DELEGATED APPLICATION REPORT

App Ref: PL/25/1447 Outline planning permission: Some matters reserved

Address: 19 PARKSIDE ROAD, READING, RG30 2BT

Proposal: The erection of four residential dwellings (phased) with associated hard and soft landscaping and parking with the construction of a new access from Parkside Road and Kearsley Road following demolition of outbuildings (outline application considering access all other matters reserved (appearance, landscaping, layout, scale))”

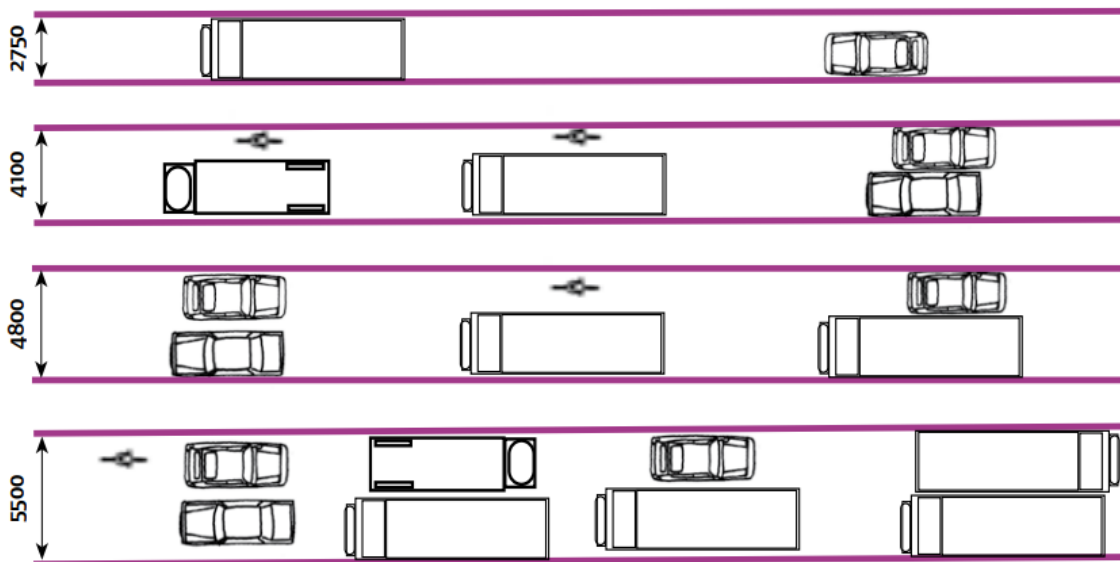
As previously advised the access will need to be 4.8m wide to accommodate vehicles entering and exiting the site. Submitted illustrative layout plan 22.19-021 (extract below) indicates a width of 4.8m; however, this measurement includes the 1.2m pedestrian footway, which is not acceptable.

While a carriageway width of 4.2m may be acceptable over short distances, this does not include the required 1.2m pedestrian footway. Consequently, the carriageway would still need to be widened to 4.8m, which is not currently shown on the submitted plans.

The 4.8m width is required to accommodate the width necessary to allow for a refuse vehicle and a car to pass one another as illustrated from the extract below from Mfs 7.1

To clarify, the 1.2m pedestrian footway must be provided in addition to the required carriageway width along the entire access from Parkside Road. As previously advised, the pedestrian footway should extend to serve all properties within the development and should therefore be clearly illustrated on revised plans.

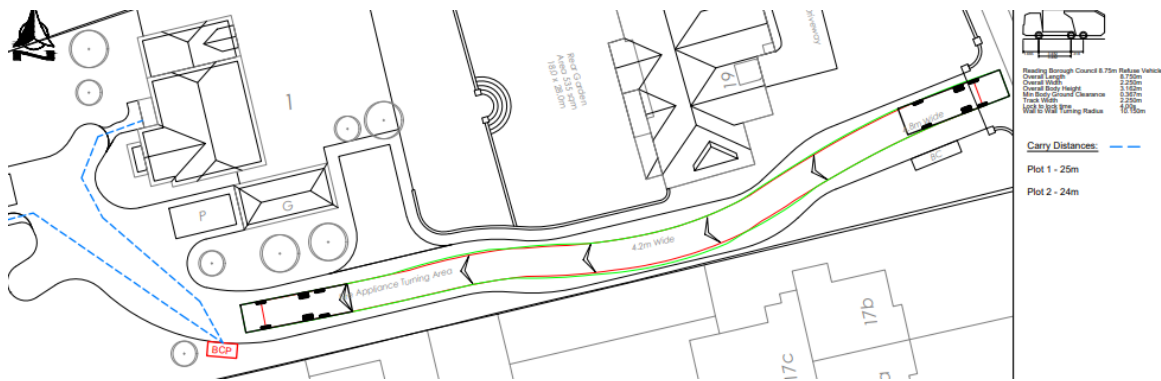
Given the constrained nature of the access and the potential for vehicles to overrun adjacent land, the applicant should provide details of appropriate boundary treatment to prevent vehicles from encroaching onto neighbouring land.

As previously advised, the Natural Environment Officer should be consulted to determine whether the proposed works may affect any adjacent trees.

All parking areas should be constructed using permeable materials to ensure that the development does not increase the surface water run-off from the site.

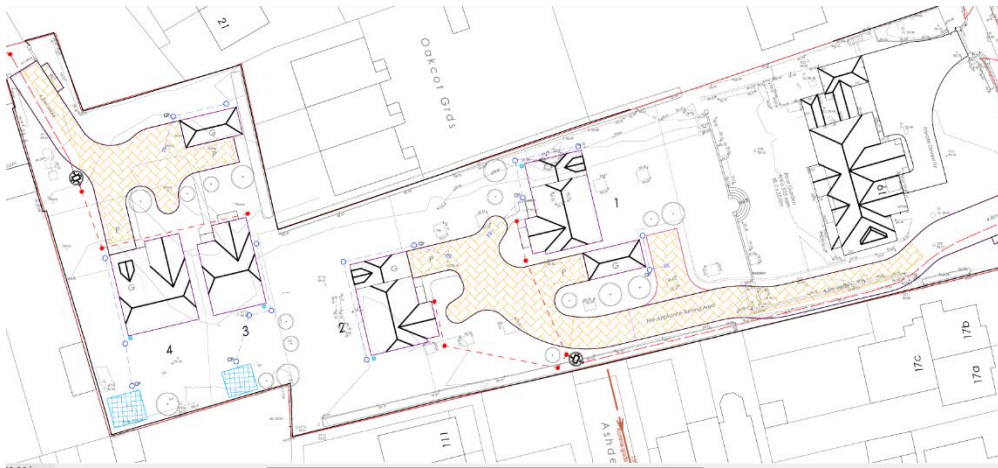
In relation to trees, there is unfortunately no Arboricultural Impact Assessment provided, as would be expected, hence I've had to extract details in the **Arboricultural Report Ref: 06260 / 2024 0.2 dated September 2025** alongside the associated **Tree Constraints Plan and Arboricultural Site Plan (Tree Removal)**. From the tree removal plan's list it can be seen that 39 trees are to be removed, of varying quality (it is assumed that the rest will be retained). From the descriptions of most of the trees, their loss would be acceptable subject to mitigation. I note that the removals include 5 B category trees: 2 young Beech (T036 & T038), a mature Himalyan birch (T065), a young Douglas fir (T070) and a young London Plane (T085). The two Beech are to be removed to allow for Plot 1, the Birch doesn't need to be removed, the D. Fir doesn't need to be removed and is not actually coloured red to indicate removal on the plan, and the London Plane requires removal to allow for the Parkside Road access.

Clarity on the reasons for removal of the Himalyan birch (T065) and Douglas fir (T070) is required given the absence of an AIA.

Whilst 4 houses may feasibly be accommodated and be acceptable in tree terms, albeit the tree impact appears not vastly different to the 6 plot layout, the normal tree assessment through submission of an AIA has not been provided which would clarify tree removal, provide principles of works within RPAs (mainly new access routes in this case), deal with services and assess impact of retained trees on future houses and gardens.
